Drip Edge Cut/Damaged by Gutter Installers or Roofers

Violation : Drip edge cut/damaged, insufficient lap and not sealed
 Code Section : 2014 FBC-R R905.2 asphalt shingles/R905.3 concrete and clay tile/R905.4 metal roofs
 2014 FBC-B 1507.2 asphalt shingles/1507.3 concrete and clay tile/1507.4 metal roofs
 Comments : Contractor shall replace drip edge material where cut/damaged by/for gutters

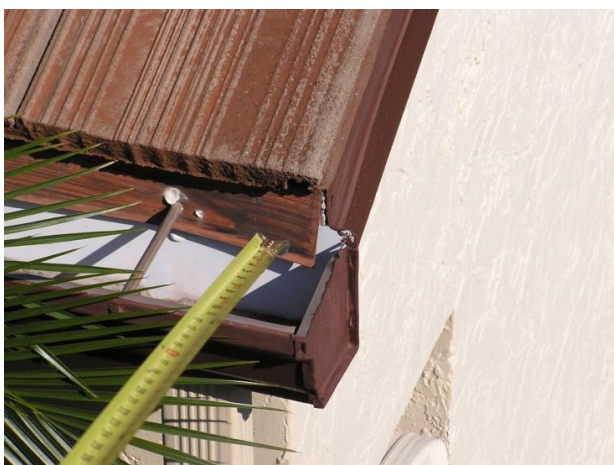
Violation : Drip edge cut/damaged, insufficient lap and not sealed

A common practice by gutter installers (and roofing contractors during reroofing) is to cut the drip edge at the inside corners, outside corners, at/near the ends of the gutters, and to notch the drip edge for the gutter spikes/supports ... all in an effort to allow the gutters to be installed up behind the drip edge.

When the drip edge is cut, the lap no longer exists, and the drip edge now has openings and cuts through its face.

- Drip edge flashing was cut for gutter installation.
- There is now a large open area in the face of the drip edge.

- The drip edge outside corners and inside corners were cut to make the original gutter installation easier.
- These gutter installers seem to have learned to avoid the drip edge ... but have now installed the gutter so low that the top of the gutter is exposed and allows rain behind the gutter (this not a roofing problem).

- Drip edge ends cut for gutter installation.
- Gutter spikes through fascia.

- Drip edge cut for the gutters, cut at the gutter ends, inside corners, and outside corners.
